LOC	DIST	REVISIONS					
E	B	P	LTR	DESCRIPTION	DATE	DWN	APVD
			BC 1	REVISED PER ECO-11-005150	28MAR2011	RK	HMR

DIMENSIONS:		DWN	02-Sep-08	MATERIAL		FINISH			
mm		SUBHASH.M		<div>TE Connectivity</div>					
TOLERANCES UNLESS OTHERWISE SPECIFIED:		CHK	02-Sep-08						
		PRAKASH.S							
		APVD	02-Sep-08						
		STEPHEN.P							
		PRODUCT SPEC							
0 PLC ±0.5 1 PLC ±0.2 2 PLC ±0.1 3 PLC ±- 4 PLC ±- ANGLES ±°		APPLICATION SPEC		NAME		SHIELDED SMD POWER INDUCTORS SERIES 3631			
				SIZE	CAGE CODE	DRAWING NO	RESTRICTED TO		
				A 4	00779	C-1625812			
		WEIGHT							
CUSTOMER DRAWING				SCALE	2:1	SHEET	1 OF 1	REV	BC 1

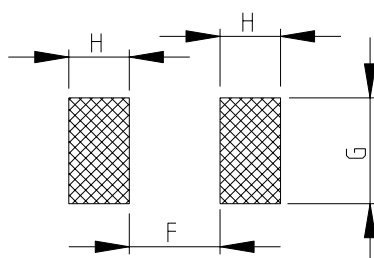
DESCRIPTION AND DETAIL OF CHANGE	EPOXY METHOD CHANGED	
	BEFORE CHANGE	AFTER CHANGE
	EPOXY ALL AROUND TERMINALS (MARKED BLACK AREA)	EPOXY ON FOUR SPOTS (MARKED BLACK AREA)
